**WHITE LAKE TOWNSHIP
PLANNING COMMISSION**
7525 Highland Road
White Lake, MI 48383
JUNE 17, 2021 @ 7:00 p.m.
Electronic Meeting

RE: Oakland Weed Harvesters - Preliminary Site Plan Review- 2nd Review

Subject: Oakland Weed Harvesters
Preliminary Site Plan Review #2
Zoned: Light Manufacturing (LM) District

The Fire Department has the following comments with regards to the 2nd review of preliminary site plans for the project known as Oakland Weed Harvesters:

SITE PLAN
 PARCEL NO. 12-01-127-001
 WHITE LAKE TOWNSHIP, OAKLAND COUNTY, MICHIGAN

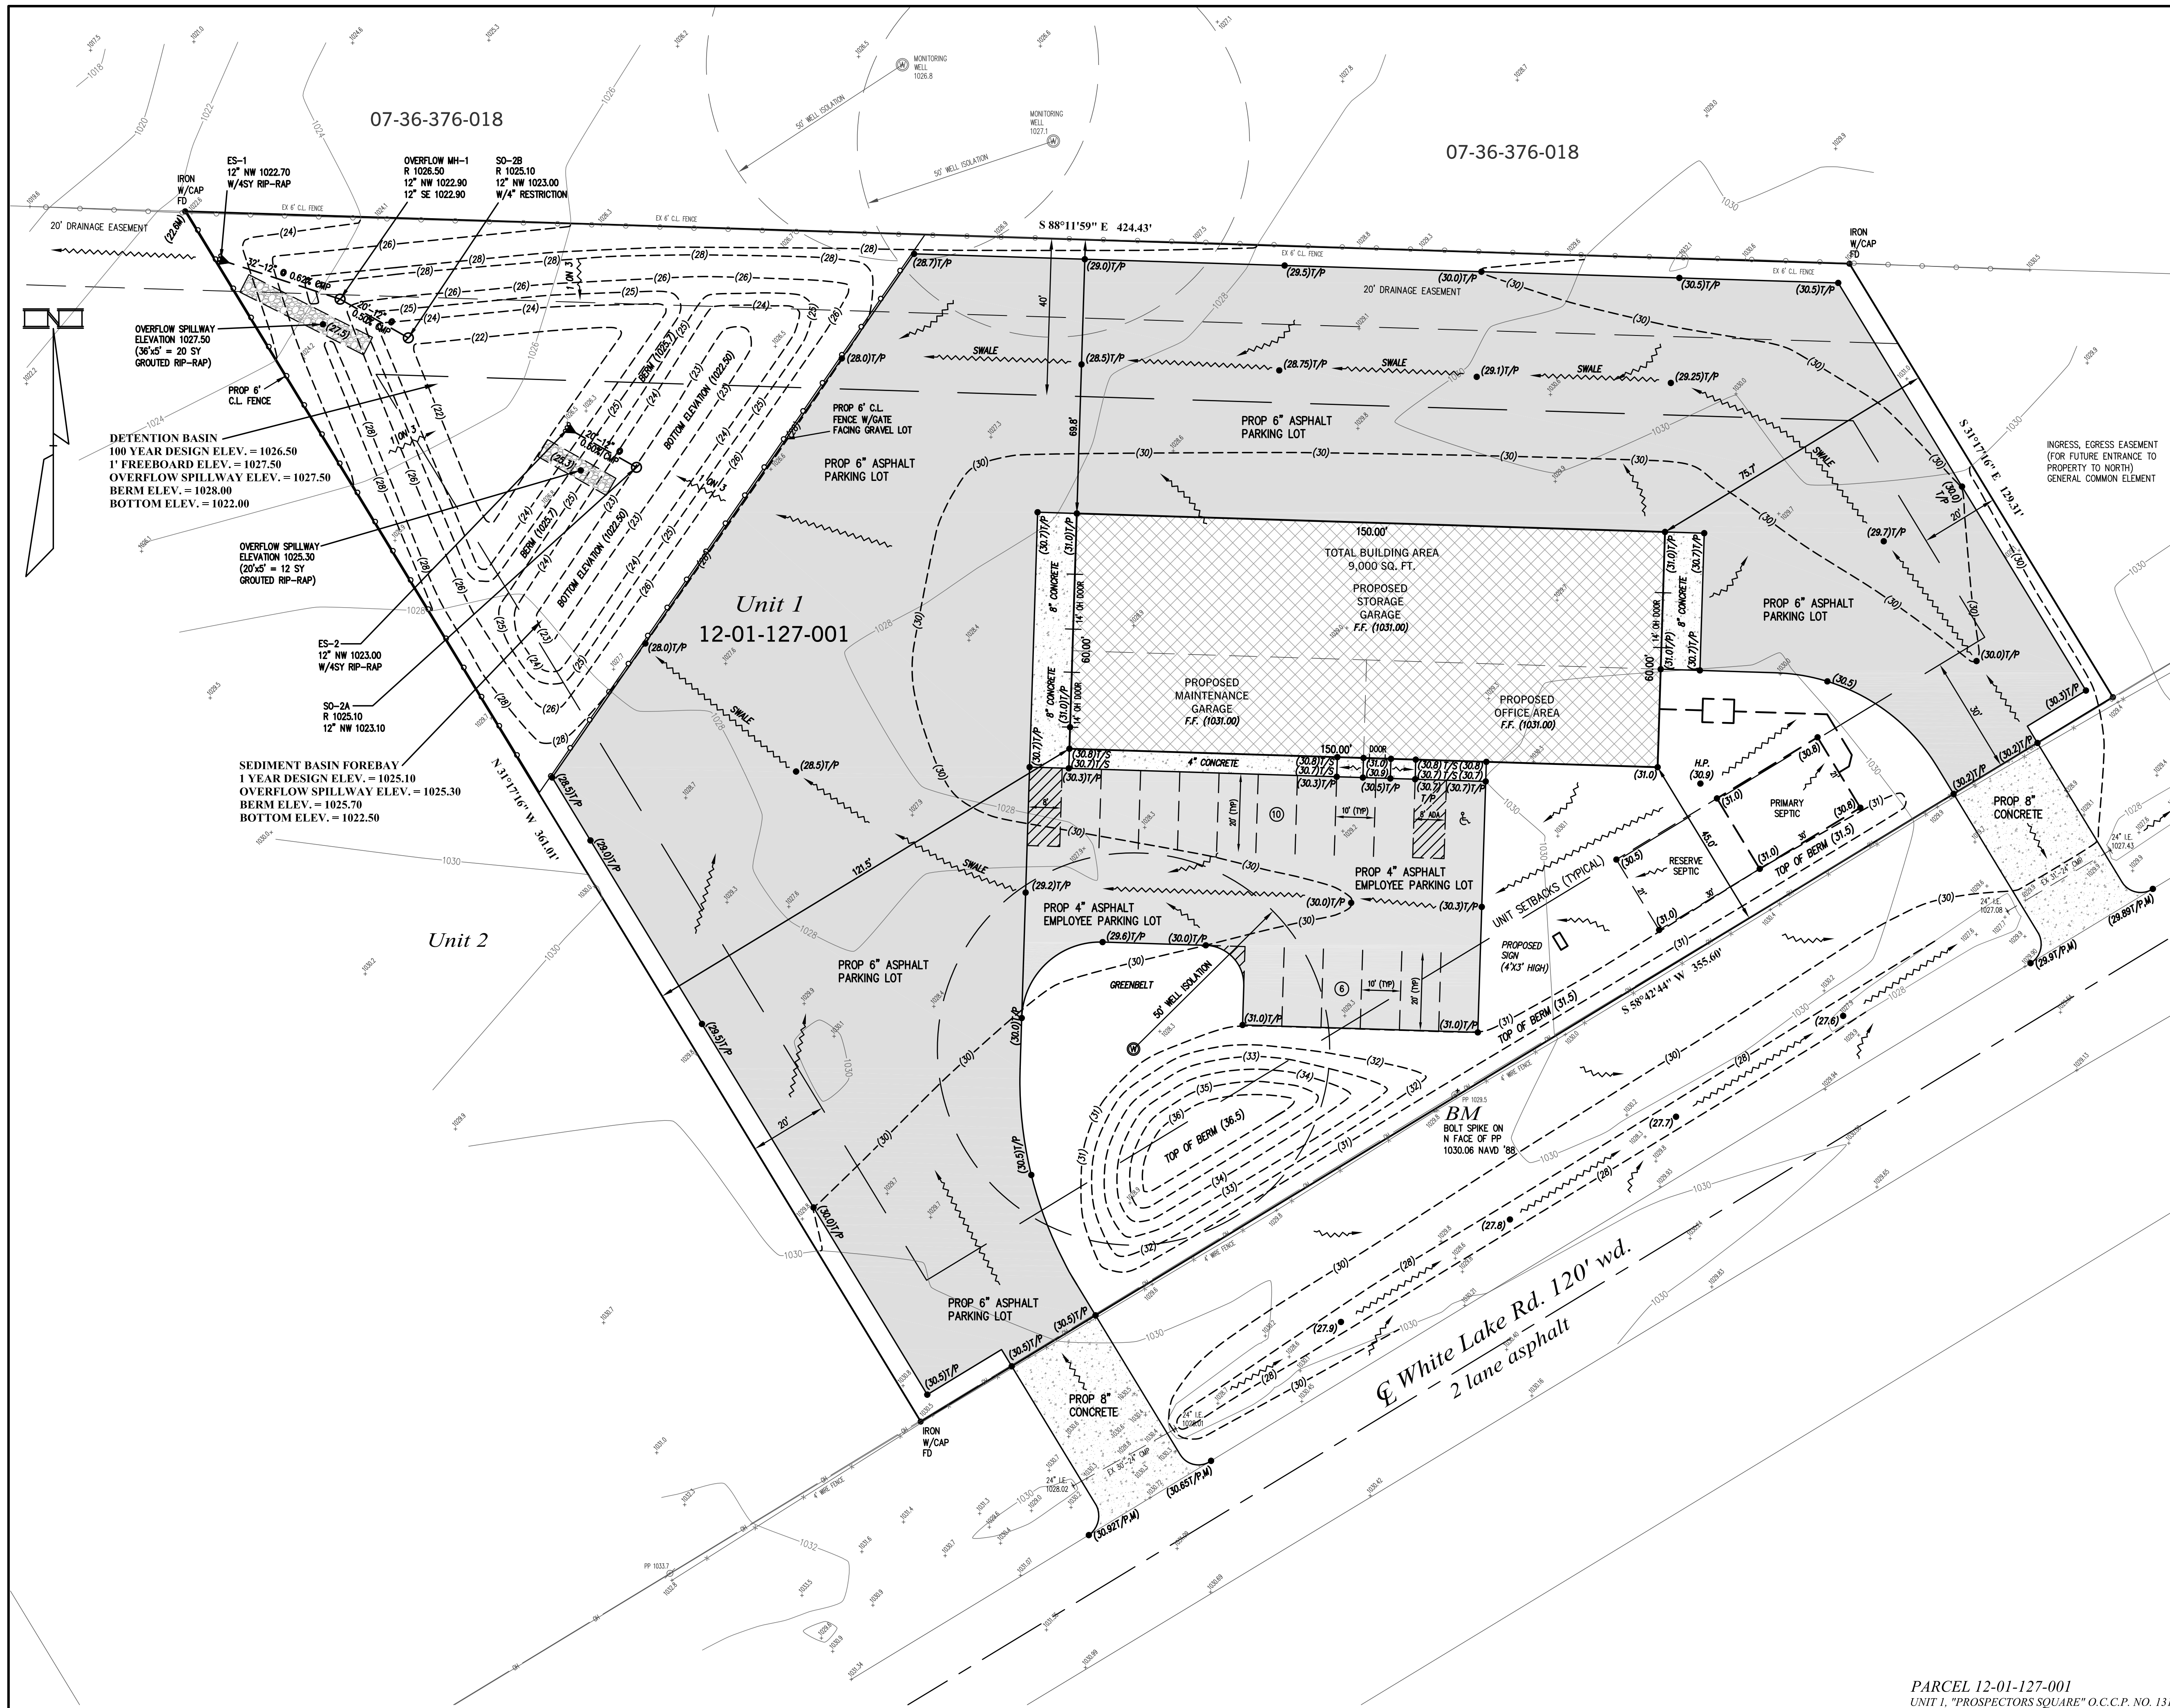
2. *Maneuvering lane between parking spaces does not meet the required 24' width per Township Ordinance. **Comment addressed. Width of maneuvering lane is 24'.***

3. *ADA spaces and ramp will need to be provided per Township requirements. ADA parking spaces and ramps will need to be paved and meet all requirements of the Township and ADA. **Comment addressed. ADA parking spaces and ramps have now been provided.***

4. *Per Township Zoning Ordinance 5.11 Q. xvii. Concrete curbing or a raised sidewalk or parking bumpers shall be placed 3' off any building with adjacent parking. Please provide one of the above on plan. **A 4' wide raised sidewalk has been added between the building and the parking stalls, however Township Zoning Ordinance 5.11 Q. xv indicates a 7 foot wide sidewalk is required if the sidewalk is intended for pedestrian use to account for the subsequent vehicle overhang.***

5. *We note that Township Zoning Ordinance 5.19 B.V indicates that all required landscape areas which abut vehicular drives, parking, or other use areas shall be separated from the vehicular use area with a 6 inch minimum concrete curb. We defer to the Planning Department or Planning Commission on how this should be applied for this use. We note the plans propose sheet drainage to the sediment forebay which would not allow for continuous curb along the detention basin.*
-

6. We note that the plans do not propose a sidewalk along the White Lake Road Frontage, we defer to the Planning Department regarding this as a requirement for this development.

4. **Site Circulation and Parking.** Manufacturing uses are required to have five (5) parking spaces plus one (1) for every one and one half (1 1/2) employees. The petitioner states that he will have eight (8) employees. This should be noted on the site plan. A total of 11 spaces are required. The petitioner is proposing 16 spaces. However; a portion of the parking along the White Lake Road frontage is in the required front yard setback. **These spaces should be removed.**

5. **Pedestrian Circulation.** Per Section 5.21 of the Zoning Ordinance, a six (6) foot wide public sidewalk is required along White Lake Road. The applicant has not proposed such a pathway on the submitted site plan.

The addition of the required six-foot public sidewalk should be condition of approval for the site plan.

DETENTION BASIN CALCULATIONS, DETAILS & NOTES
 PARCEL NO. 12-01-127-001
 WHITE LAKE TOWNSHIP, OAKLAND COUNTY, MICHIGAN

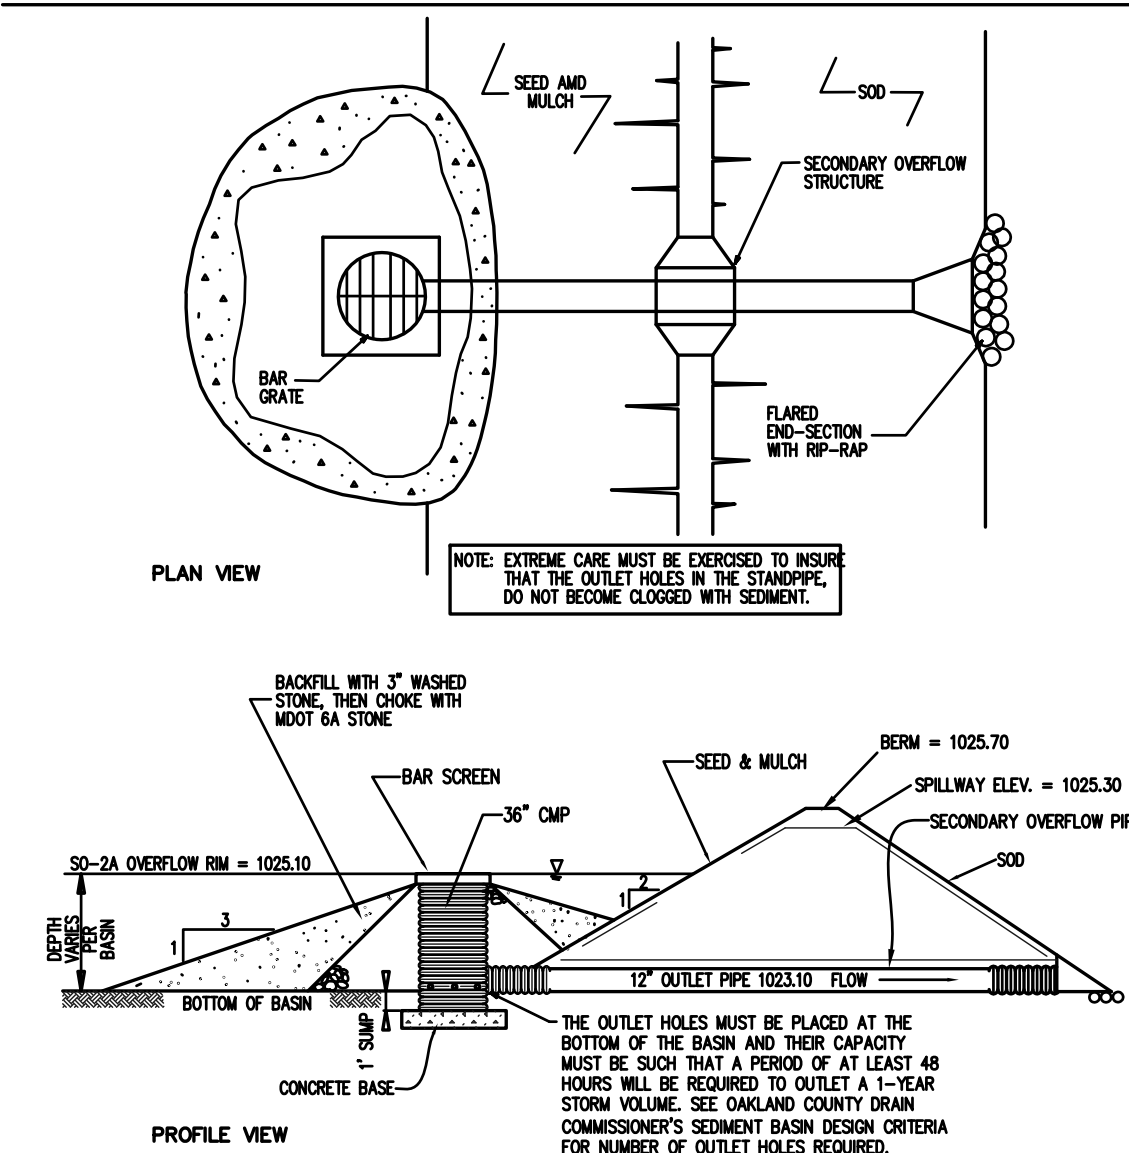
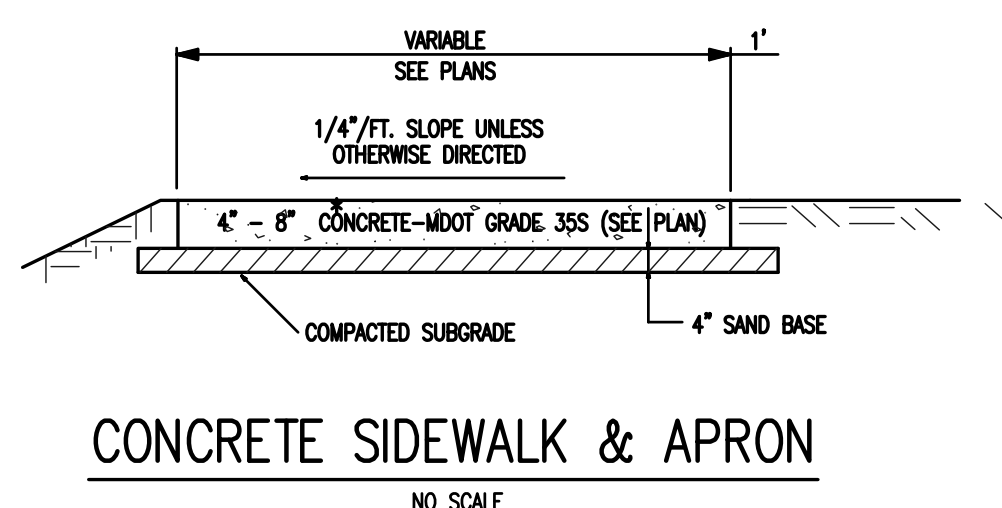
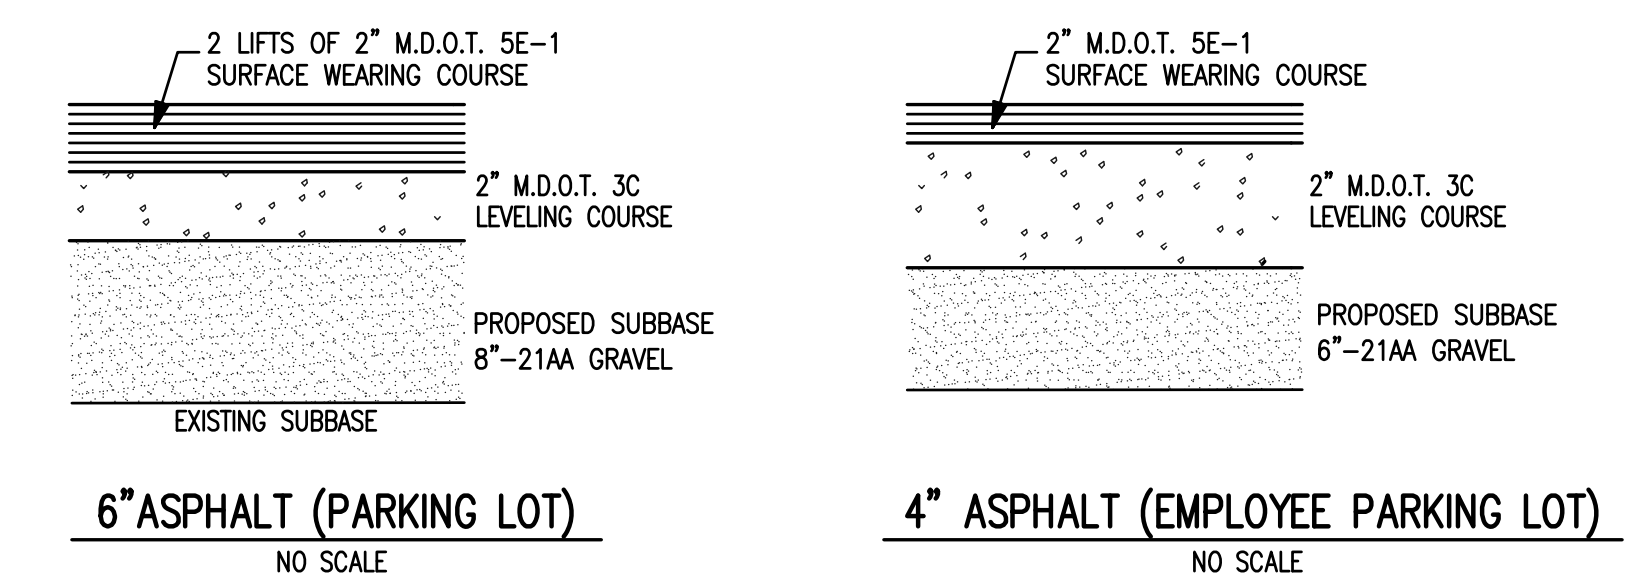
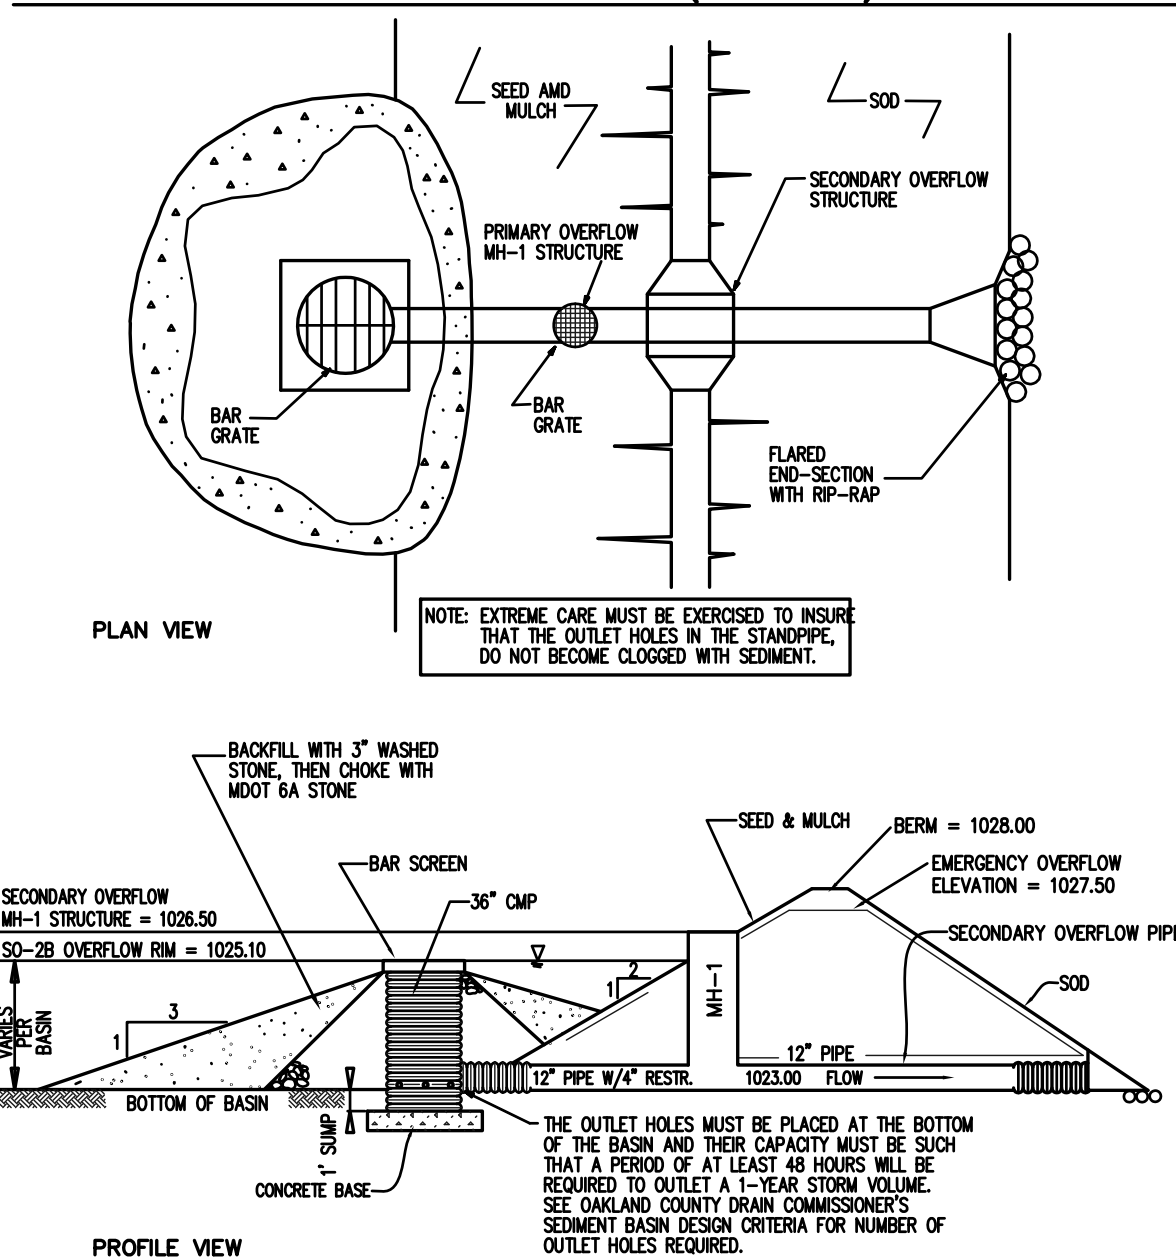
1. *The discharge for the proposed detention basin is not taking the intended easement path toward the ultimate outlet in the rear of the overall Prospectors Square development. This is per the Prospectors Square plans, Master Deed and Exhibit B documents. Furthermore, the proposed point of the basin discharge suggests that flows will enter on to off site property located in Springfield Township which would not be allowed unless a drainage easement is secured. This also applies to future flows from proposed basin spillway location.* **Comment addressed, design engineer has adjusted the outlet location and shown drainage flow lines within the drainage easement, this meets the requirements of PSP review. At the time of Final Site Plan/Final Engineering Plan submittal further detail will be required to demonstrate that the basin discharge will be confined within the drainage easement.**

2. *The proposed detention basin shall have a sediment forebay consistent with Township and Oakland County standards.* **Comment addressed. A sediment forebay is now proposed.**
